1984 Corvette: Service Bulletin: Generator Noise (Moan) at Idle with Air Conditioning On

Source: Chevrolet Dealer Service Bulletin

Bulletin Number: 84-151, Section 6D (VIy)

Date: June 1984

FIGURE 1

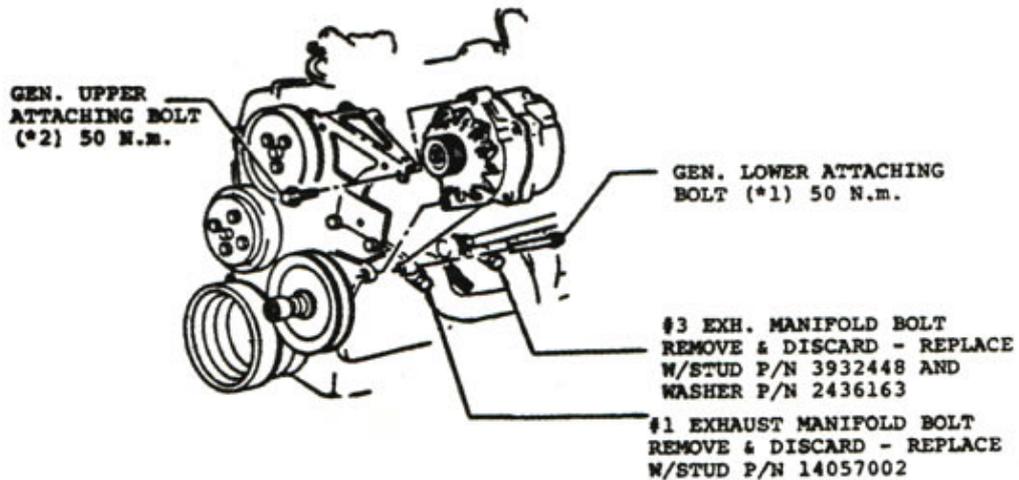
Some 1984 Corvettes may exhibit the subject noise, which is commonly defined as a "moan". This noise is induced into the generator by belt excitation when the air conditioning compressor is "on".

The following service procedure has been developed to reduce this noise by using three (3) new tubular braces and fasteners to replace the generator vibration period, which is the primary noise source.

1. Remove the generator rear support brace. Discard the support brace, attaching nut and attaching bolt.
 2. Remove and discard #1 and #3 L.H. exhaust manifold to cylinder head attaching bolts (see Figure 1).

- NOTICE: Washer is to be installed on stud between stud hex and exhaust manifold.
5. Remove the serpentine belt from the generator pulley.
 6. Loosen generator attaching bolts (2). (See Figure 1).

3. Install stud, P/N 14057002, in place of discarded #1 bolt and torque to 35 N.m.
 4. Install stud, P/N 3932448, and washer, P/N 2436163, in place of discarded #3 bolt and torque to 35 N.m.

9. Mandatory torque sequence (Figures 1 and 2):

- Generator lower attaching bolt 50 N.m.
- Generator upper attaching bolt 50 N.m.
- Long tubular support brace to generator, attaching bolt 35 N.m.
- Two (2) short tubular support braces to generator, attaching bolt 50 N.m.
- Three (2) tubular support braces to three (3) exhaust manifold studs, 25 N.m. three (3) attaching nuts.

FIGURE 2

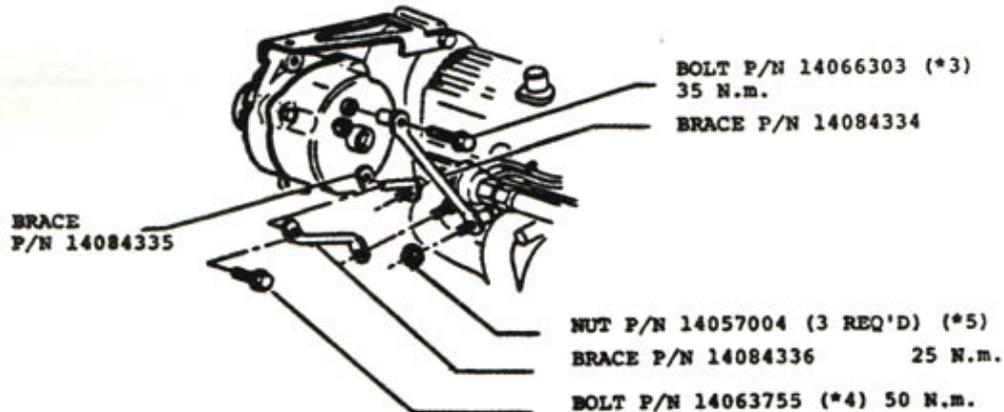
7. Install three (3) tubular braces on the exhaust manifold studs as shown on Figure 2 and loosely retain with attaching nuts in three (3) places.
 8. Install bolt, P/N 14066303, in longer single brace and bolt, P/N 14063755, in two (2) short braces. Loosely install bolts into generator housing (see Figure 2).

The B+ wire on the generator should not contact the support brace(s). If necessary, disconnect the battery and loosen the B+ cable eyelet, on the generator, and rotate the B+ wire to clear the support brace(s). Re-torque the eyelet attaching nut and install the battery cable.
